24 October 2018

Hauraki District Council: Request for Further Information under Section 92 of the Resource Management Act 1991 (RMA) – Application number 202.2018.0000873.001 – Kaimai Wind Farm Limited

S92 Requests and Responses

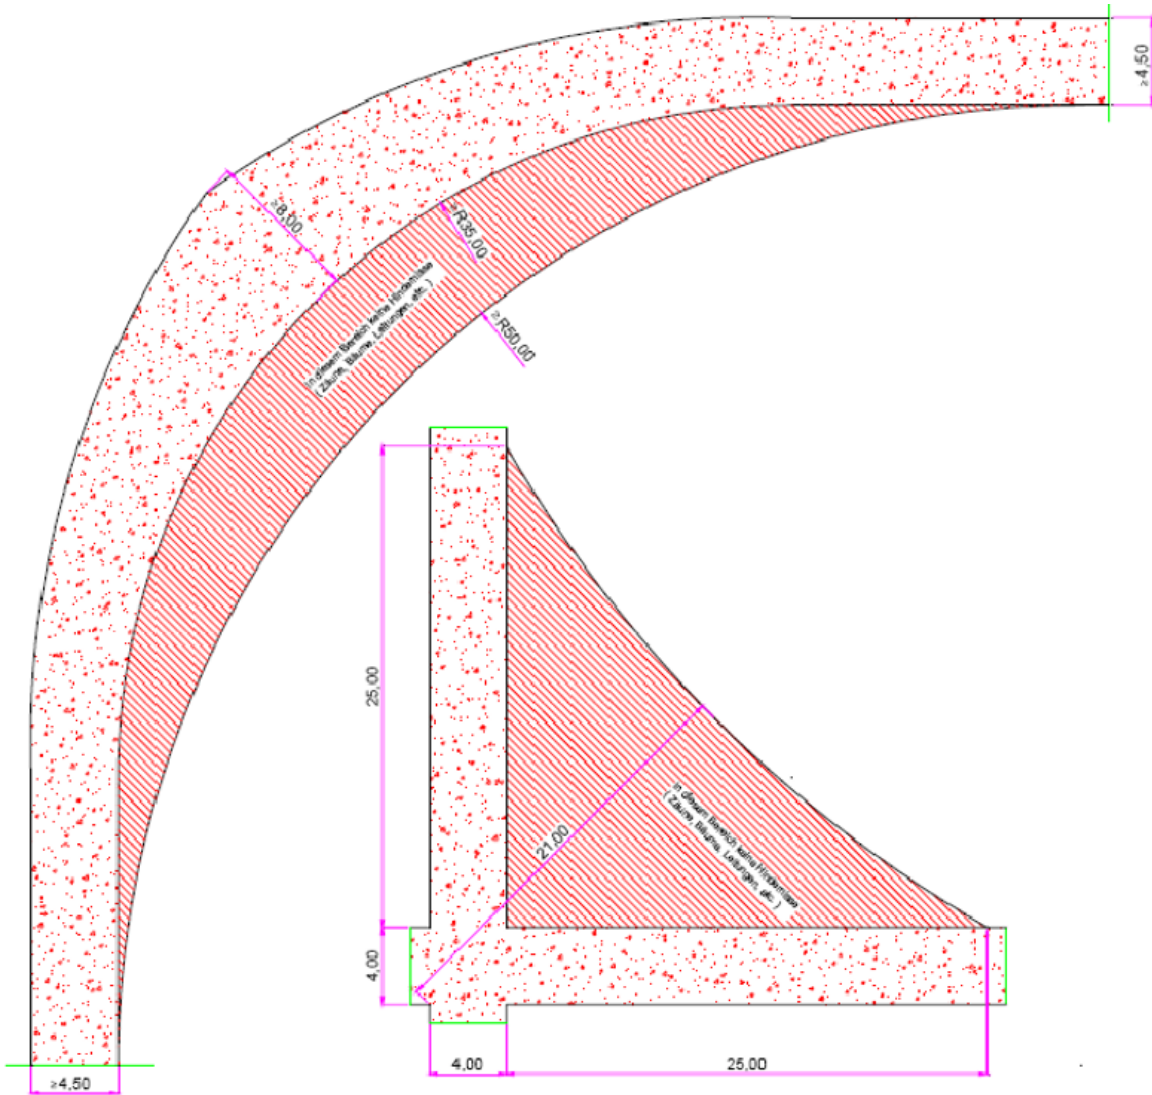
40. P13 The wording within the diagrams provided in Figure 2 is not readable.

Response: The diagram (see below) is taken from a publication and the wording is in German. It is not possible to replicate the diagram with any more clarity but the hatched area relates to the clear air space to allow the body of the transporter to negotiate the corner.
